Project	IEEE 802.16 Broadband Wireless Access Working Group http://ieee802.org/16 >			
Title	TEK generation and update for Handover			
Date Submitted	2008-03-17			
Source(s)	Kyeong-Tae Do Eun-Sun Jung Voice: +82-31-279-5748 E-mail: kyeongtae.do@samsung.com esleon.jung@samsung.com			
	Geunhwi Lim Samsung Electronics Co., LTD			
Re:	LB 26b			
Abstract	The effort to reduce the HO latency is currently being discussed. Main idea is to exchange in the serving BS the information which is required at the target BS. This contribution suggests the way of sharing TEKs.			
Purpose	Accept the proposed specification changes on IEEE P802.16Rev2/D2			
Notice	This document does not represent the agreed views of the IEEE 802.16 Working Group or any of its subgroups. It represents only the views of the participants listed in the "Source(s)" field above. It is offered as a basis for discussion. It is not binding on the contributor(s), who reserve(s) the right to add, amend or withdraw material contained herein.

TEK generation and update for Handover

IEEE C802.16maint-08/158r1

Figure 164 – TEK state machine flow diagram

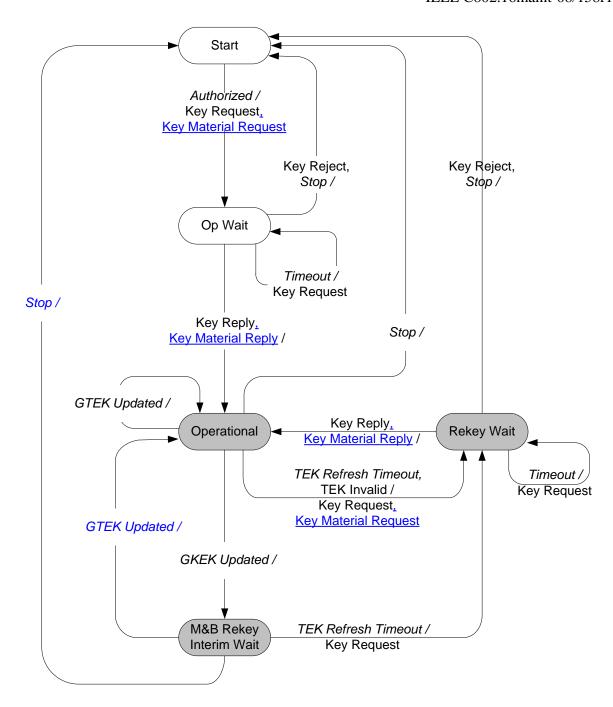
The TEK state machine consists of seven five states and eleventen events (including receipt of messages) that may trigger state transitions. Like the Authorization state machine, the TEK state machine is presented in both a state flow diagram (Figure 164) and a state transition matrix (Table 206). As was the case for the Authorization state machine, the state transition matrix shall be used as the definitive specification of protocol actions associated with each state transition.

Shaded states in Figure 164 (Operational, Rekey Wait, Rekey Wait, Rekey Reauthorize Wait, and M&B Rekey Interim Wait) have valid keying material and encrypted traffic may be sent.
